Addendum #4

Date: June 5, 2024

Project Name APMT Phase IV Yard Expansion

Project # 11261

PROJECT NO: 4484 | DWG NO: P21 | REV: A

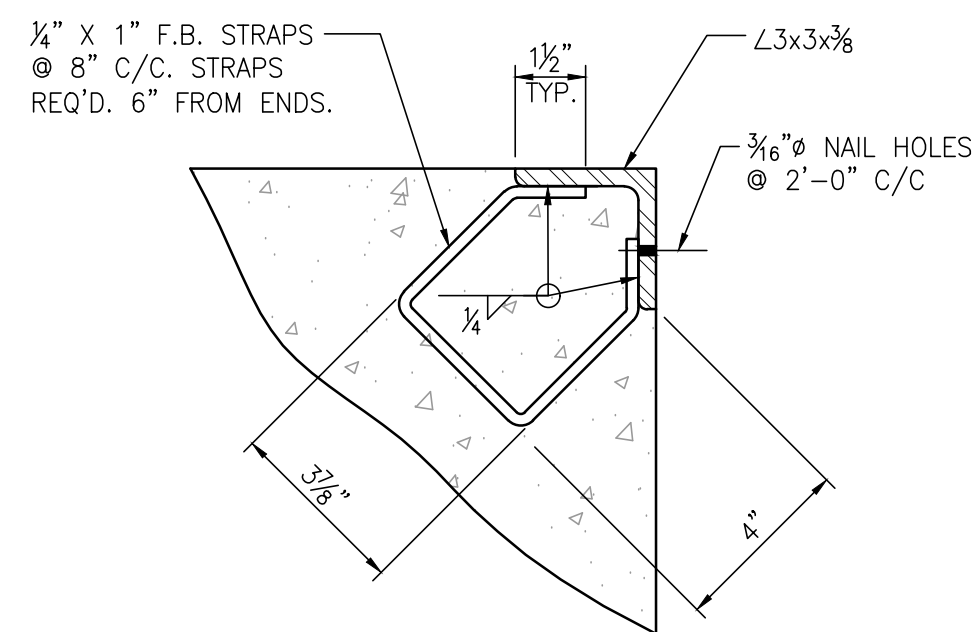
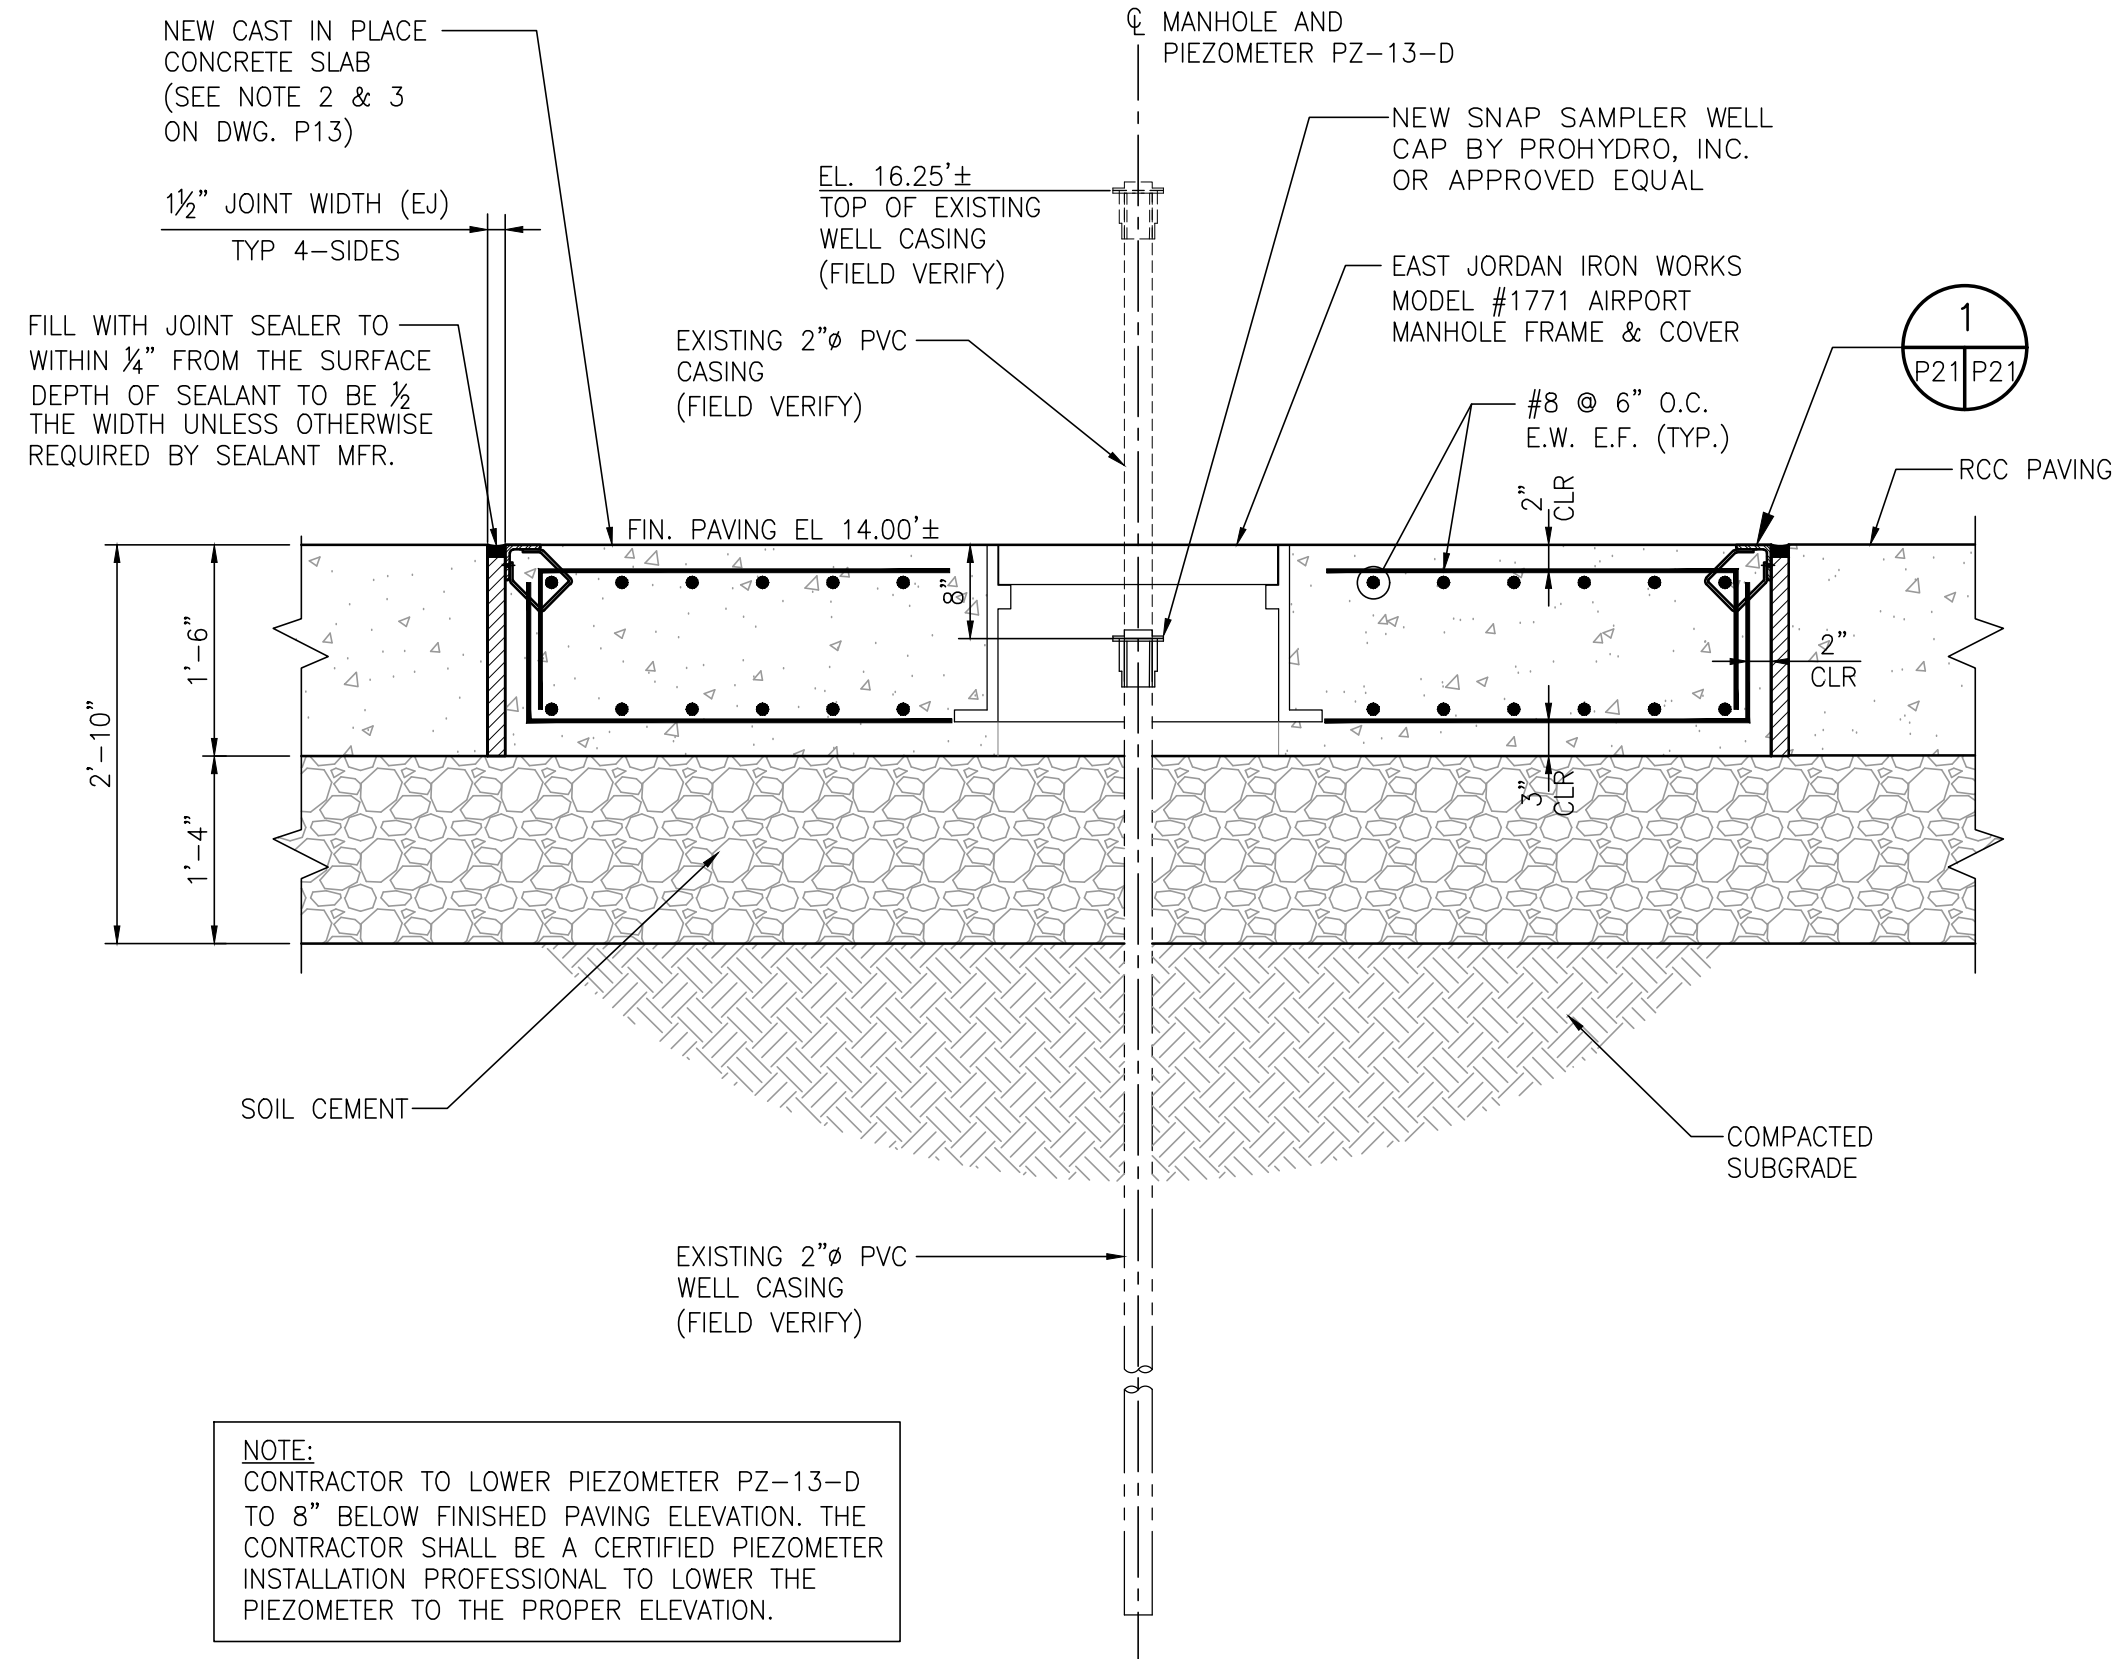
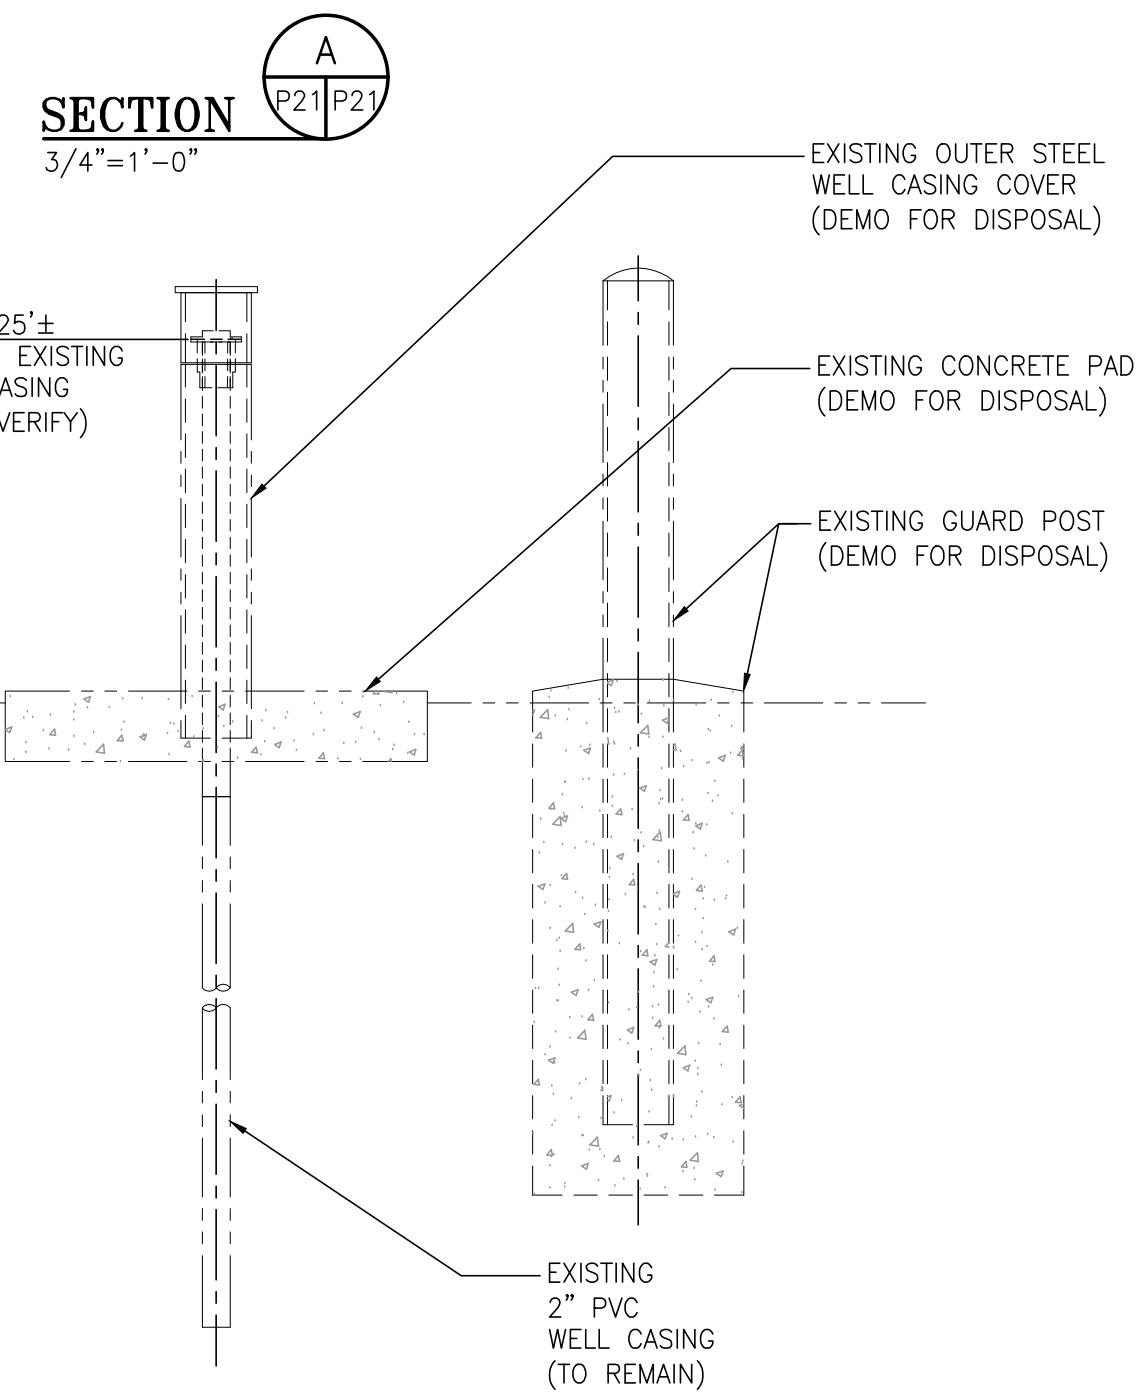
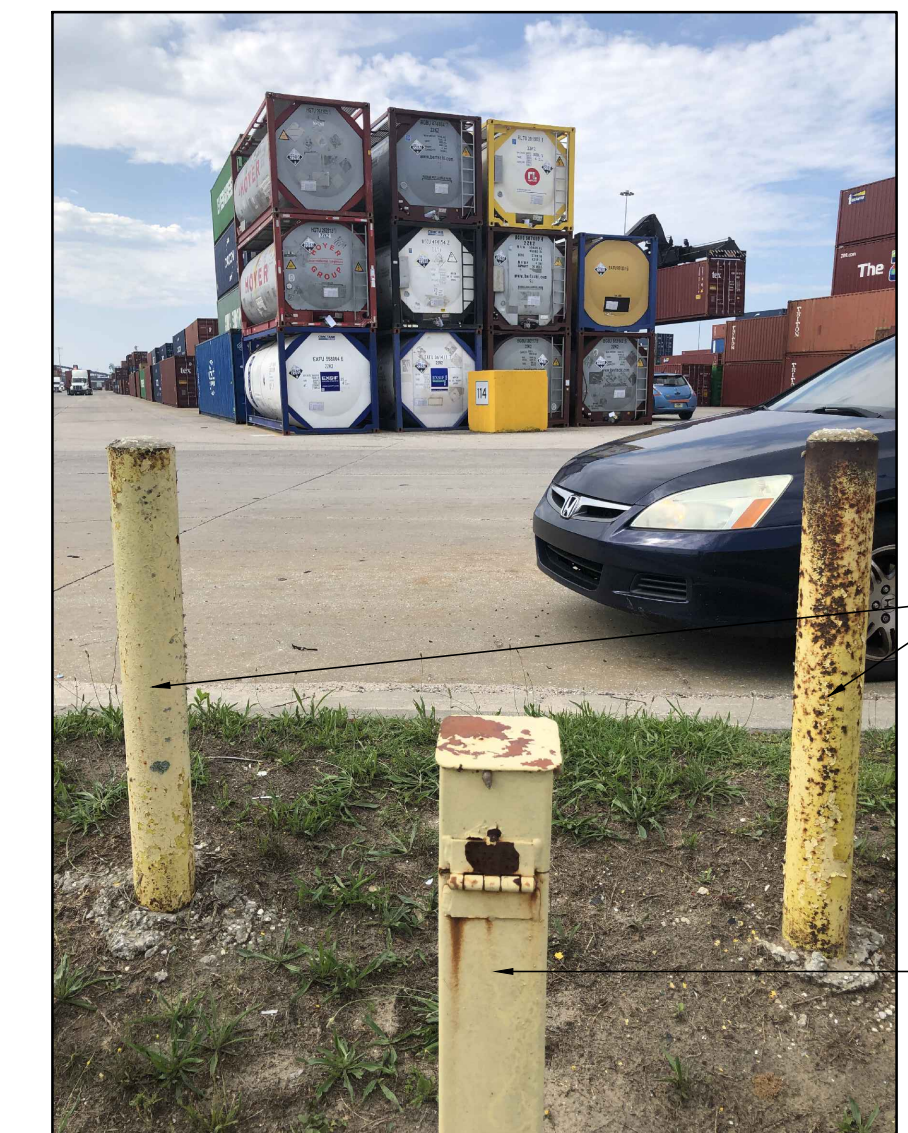
- SEE DRAWING G3 FOR PROJECT GENERAL NOTES.
- SEE DWG. G7 & G8 FOR MONITORING WELLS MW-1 THRU MW-5 LOCATION POINT COORDINATE TABLE (BY OTHERS).
- THE CONTRACTOR TO PROVIDE CONCRETE JERSEY BARRIERS ENCLOSING AN AREA APPROXIMATELY 20' X 16' ALL AROUND EXISTING PIEZOMETER PZ-13-D FOR ITS PROTECTION DURING CONSTRUCTION ACTIVITIES.

NO.	REVISION	DRAWN	CK'D	APPD	DATE
B	REVISED FOR BID -- ADDED MW-1 THRU MW-5 & PZ-13-D CIP SLAB	RST	MED	RSG	06/04/24
A	ISSUED FOR BID	WMB	MED	RSG	04/05/24
